**PASSENGER / CREW 45° RELEASE
LAP BELT BUCKLE ASSEMBLY**

SERVICE BULLETIN NUMBER
1108435-25-01

Subject: REPAIR OR REPLACEMENT OF PACIFIC SCIENTIFIC LAP BELTS
AND RESTRAINT SYSTEMS WHICH INCORPORATE THE 1108435
45° RELEASE LIFT LEVER BUCKLE ASSEMBLY

FIGURE 1

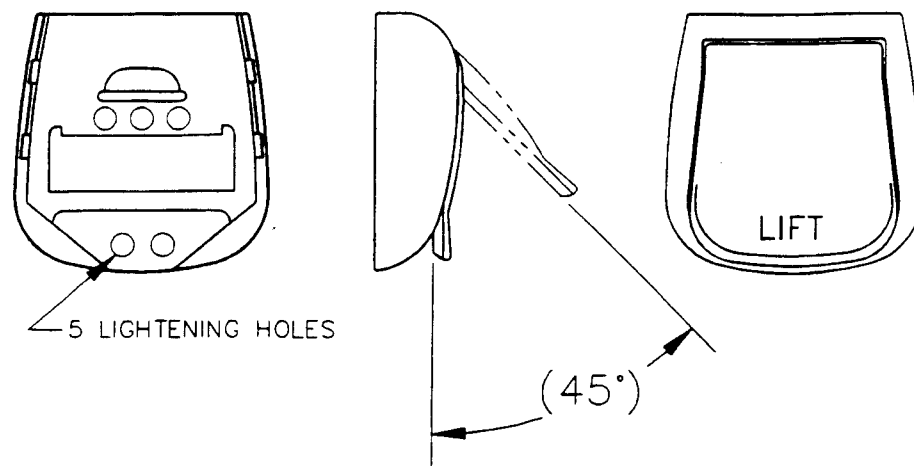
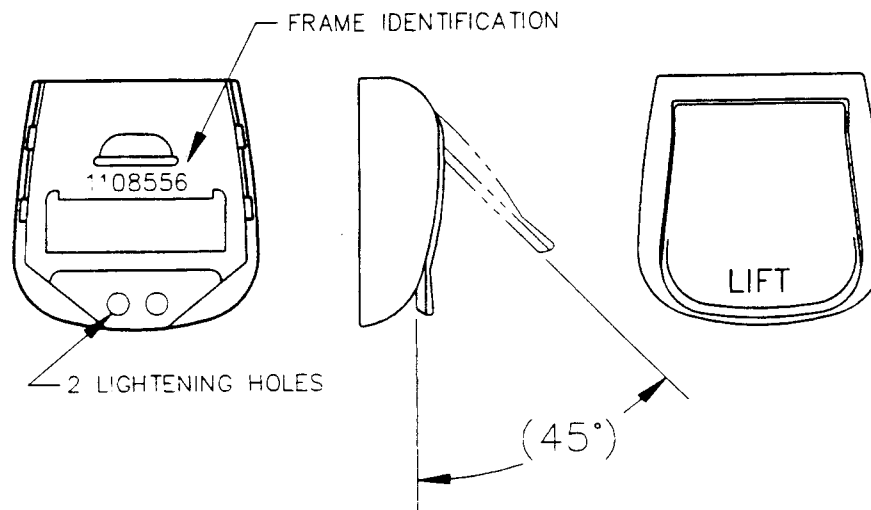
lever characteristic, but more so by the composite plastic components which enclose the metal load carrying members of the buckle. The existing buckle design, which must be replaced, has a total of five lightening holes in the bottom frame surface. The replacement buckle will only have two lightening holes (towards the back portion of the frame, opposite from where the plug-in connector inserts into the buckle). The replacement buckle will also have an identification marking indent stamped on the bottom surface, which represents the frame detail part number 1108556. See Figure 1 and 2 for reference.

NOTE: *For purposes of inspection and future reference, the markings on the bottom surface of the buckle (1108556) and the reduction in the number of lightening holes (two towards the back of the frame) shall be the method of identification for compliance with this Service Bulletin. In addition to the buckle identification, the identification label of each lap belt assembly incorporating a lift lever buckle, shall have an "M" included in the basic part number.*

IDENTIFY EXISTING 1108435 BUCKLES BY COUNTING THE FIVE LIGHTENING HOLES IN BOTTOM SURFACE OF FRAME

UPGRADED 1108435M BUCKLE DESIGN HAS AN IDENTIFICATION MARKING AND TWO LIGHTENING HOLES IN THE BOTTOM SURFACE OF FRAME
